S4.55(8) MODIFICATIONS

ISSUED FOR s4.55(8) LODGMNT
NOT FOR CONSTRUCTION

VPM
9-11 VICTORIA PARADE, MANLY, NSW

DRAWING TITLE		PROJECT	
FIRST BASEMENT PLAN		VPM	
SCALE	STATUS	NUMBER	REVISION
1 : 100	s4.55 (8)	A1.01 b	A

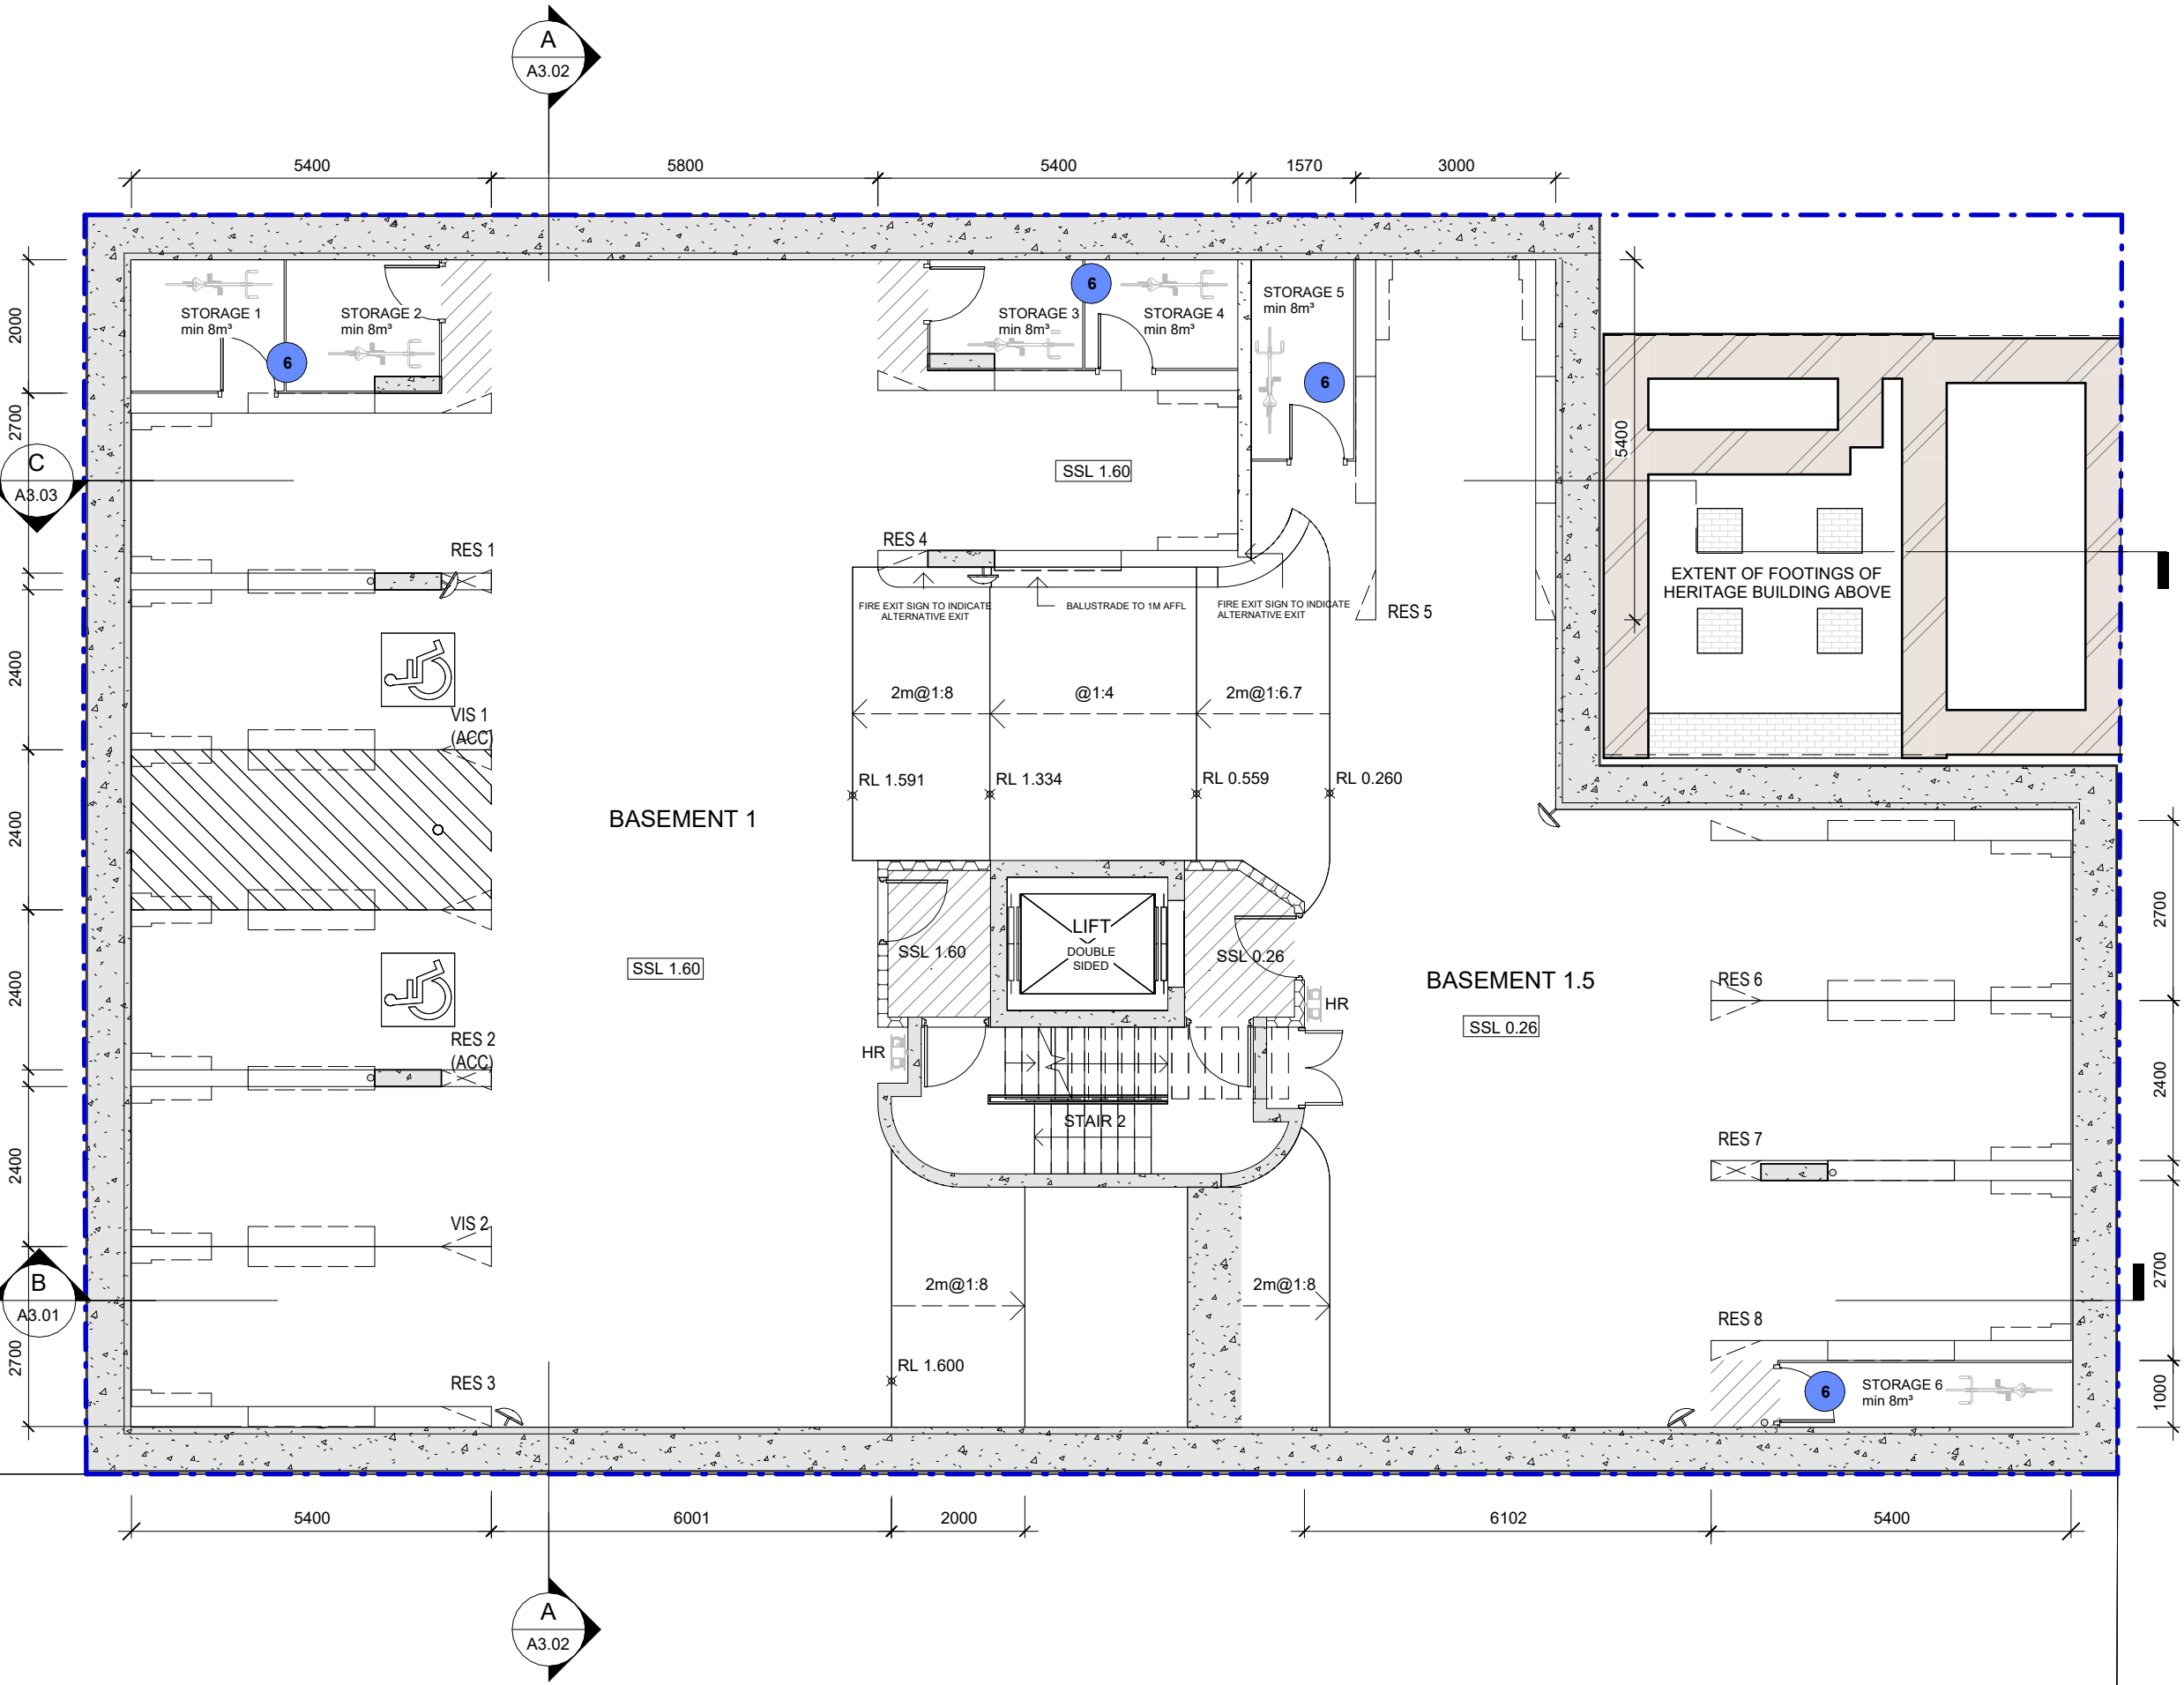
- Retail 1 on Ground floor has been pushed out to enhance the usable area and to suit new columns for balconies above.
- The front facade's angle has been adjusted to enlarge the front balconies and comply with ADG regulations of balcony size.

- Front balconies on level 1 and level 2 were extended to the north east to align with the approved balconies above to avoid looking 'top-heavy' and unbalanced.

- Level 4 brick wall shifted to align with adjacent brick walls.
- Cladding colour proposed to be off-white to visually lighten the bulk of the upper floors.

- Allocation of 1 bicycle space per unit in large storage cages in lieu of separate bicycle parking to satisfy the intention of condition 43D.
- Private roof terrace introduced to improve amenity of unit 14. The glass stair enclosure is not readily visible from the street and has no real impact on privacy, bulk or overshadowing.

- Increase in width of high-light windows to improve ventilation and natural lighting in the bedrooms with no privacy impacts.
- Minor adjustment to the GFA due to the above- still less than LEC approved FSR 3:1.

- Window heads have been lowered to 2.58m to fit services
